**MEMORANDUM – COASTAL ENGINEERING REVIEW
SOUTHEAST REGION OFFICE – IMPLICATIONS OF REMOVAL OF
DISPLACED RIPRAP AND JETTY CREATION
TAR 20171**

4 May 2022

INTRODUCTION AND TECHNICAL ASSISTANCE REQUEST (TAR)

Figure 11. Proposed Shoreline Stabilization at Hemmer Point (NPS 2021)

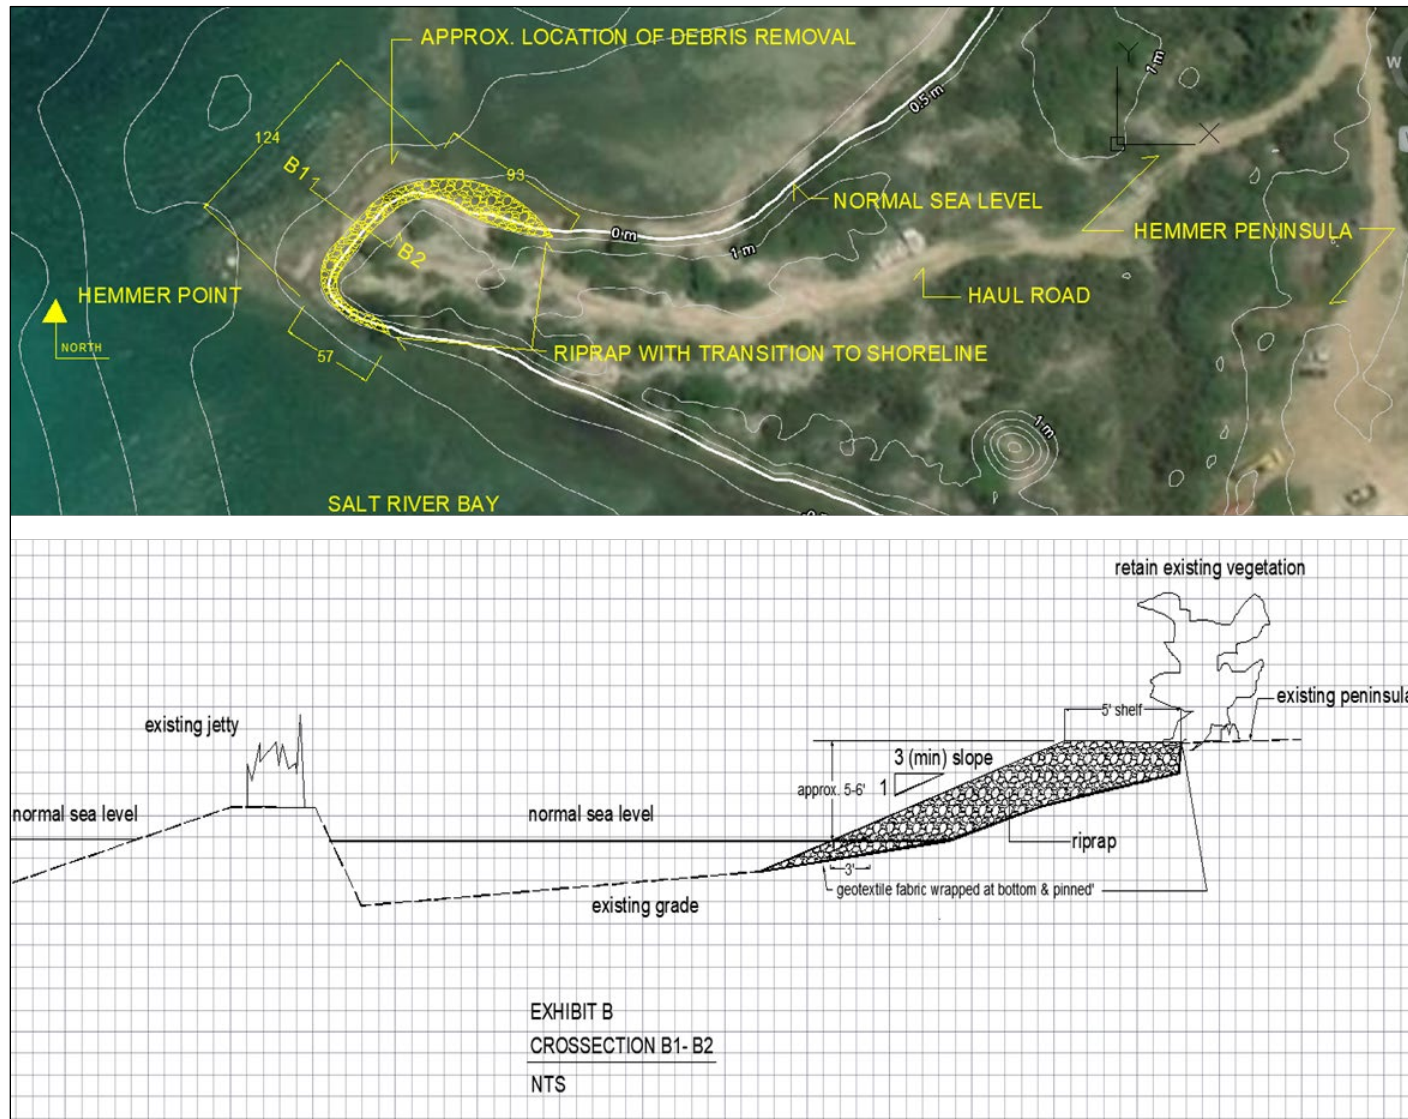
Although the scope of work provides a suggested size of riprap, it does not provide the calculations or assumed conditions used to determine this design and specification. The plans also do not show an engineer's stamp on them, so comments regarding the technical qualification of the design engineer cannot be made. It is therefore difficult to comment on whether the proposed size will adequately stabilize Hemmer Point Peninsula.

The proposed plans do not include a readable scale; however, the cross section shows the riprap extending below the "normal sea level" line. Although one cannot fully comment without a scale, and the definition of "normal sea level" is not understood, it should be noted that the MHHW elevation is +0.35 feet VIVD09 (NOAA 2022c and figure 10), and it is therefore suggested that the design be further evaluated by the design engineer to clarify whether the design intends for the riprap to be placed below MHW. Placement of riprap to an elevation down to at least the MLLW elevation is recommended to provide the desired shoreline stability, but this results in a situation that would necessitate further regulatory interactions/submittals.

The SOW to stabilize Hemmer Point Peninsula provided at the time of this TAR was in a draft form, so additional detail may now be available; however, the plans in the version reviewed for this document do not have an engineer stamp, readable scale, or calculations to support the design. Additional review of these plans is suggested to ensure that the design aligns with permits and storm conditions to provide adequate stabilization to Hemmer Point. However, given the recent accretion of material in front of Hemmer Point, the placement of riprap to prevent erosion of the point may no longer be necessary.
